Conceptual Site Plan Review Report

Project Name: Harris Teeter
Applicant: Southeastern Property Acquisitions LLC c/o Venable LLP
Representative: Evan Pritchard
CPHD Staff Lead: Matthew W. Pfeiffer

Staff Meeting with Applicant: September 27, 2017
Report Issued: October 20, 2017

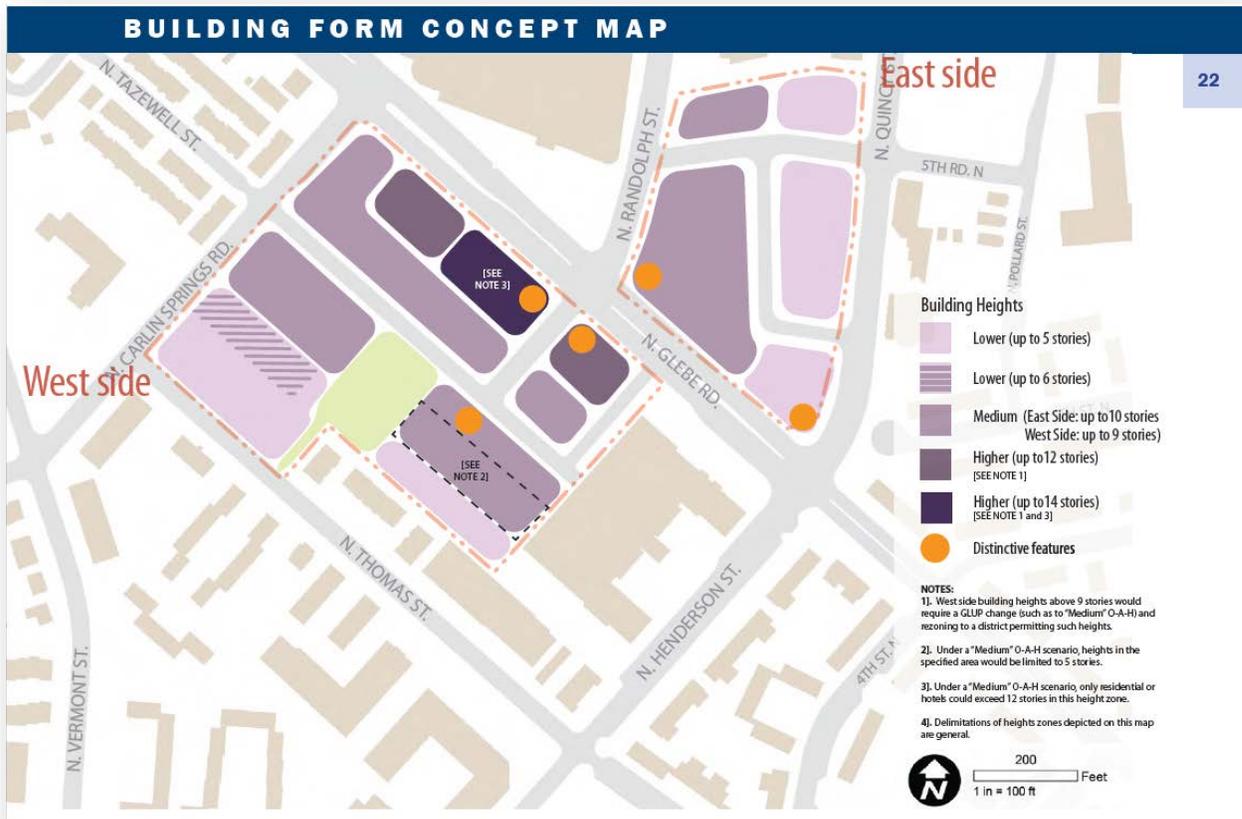
- The applicant proposes achieving 3.028 FAR across the site utilizing the R-C district. This is below the base density of 3.24 FAR permitted. The two proposed buildings are five stories of stick frame construction above a double-height podium; the R-C district allows for heights of up to 95 feet, which is not being utilized.

- The N. Quincy Street Plan Addendum recommends that buildings achieve greater height than is being proposed, with significantly smaller footprints than are being proposed. This is a deliberate strategy to offset the density required for redevelopment with needed public facilities.

- In order to deliver the public facilities (parks, roads, utilities) recommended by the N. Quincy Street Plan Addendum, the applicant should examine locating parking garages underground, shrinking building footprints, and achieving greater building heights in conformance with plan addendum recommendations.

- The proposal appears to invert the recommended retail-focus treatment of Glebe and Randolph, where Glebe (where retail is required) retail frontage is downplayed, and Randolph extension (where retail is optional) showcases retail edge.
- It is understood that much of the project design is driven by the need to phase the project such that the existing Harris Teeter can remain open to customers while the new store is under construction. The applicant should explore splitting the project into multiple phases (more than just two), in which parking for the existing store could be built on the ASC site and utilized by customers while construction on the existing Harris Teeter parking lot commences.

- The plan addendum recommends a roughly half-acre new park located in the middle of the subject block. This park is recommended for active recreation uses, and is intended to serve the neighborhood to the south and west and to provide relief from the building bulk anticipated on the block.
- The proposed plaza adjacent to Glebe Road does not achieve the plan addendum's vision for open space on the subject block.

- Proposed street sections do not meet those recommended in the Plan Addendum.
- Care should be taken to ensure that the character and design of the streets conform to the Urban Center Local MTP typology, particularly as they relate to the applicant's proposal to have streets run through parking garages associated with the project. Structures and ramps as included in internal circulation routes are not compatible with these streets operating as public streets.

- N. Tazewell Street is shown to be utilized as an alternative vehicular access to the parking garages for the project. It is not recommended that N. Thomas Street be utilized for this purpose.

- The proposed shared space/plaza area located off N. Glebe Road at the grocery store access from N. Glebe is an undesirable location for such as plaza. The vehicular traffic volume is too high for such a shared space.

- Proposed urban form is inconsistent with the plan addendum recommendations; the plan addendum recommends significantly higher building heights, smaller building footprints, and the achievement of light and air through new streets and open space. In contrast, the applicant proposes lower building heights with little relief in the way of open space, and internalized, privately designed streets.

- Above grade parking is not the most desirable use of space and does not contribute to urban environment.
- Grocery store frontage along Glebe Road appears to comprise large percentage of blank wall, does not add interest, activation, or enhance the pedestrian/streetscape experience;

- Ground floor frontages along Glebe Road should be reconsidered for consistency with Plan Addendum guidance.

- The applicant should reexamine the building form, height, open space, and transportation recommendations of the N. Quincy Street Plan Addendum and redesign the subject proposal to meet as many of the recommendations as possible.
- A site plan that does not deliver the public facilities (streets, open space) envisioned for the block will likely not be supported by staff.
- The applicant should reexamine some of the development assumptions that went into the design of this project, including above-grade parking, stick-frame construction, and splitting the project into only two phases.
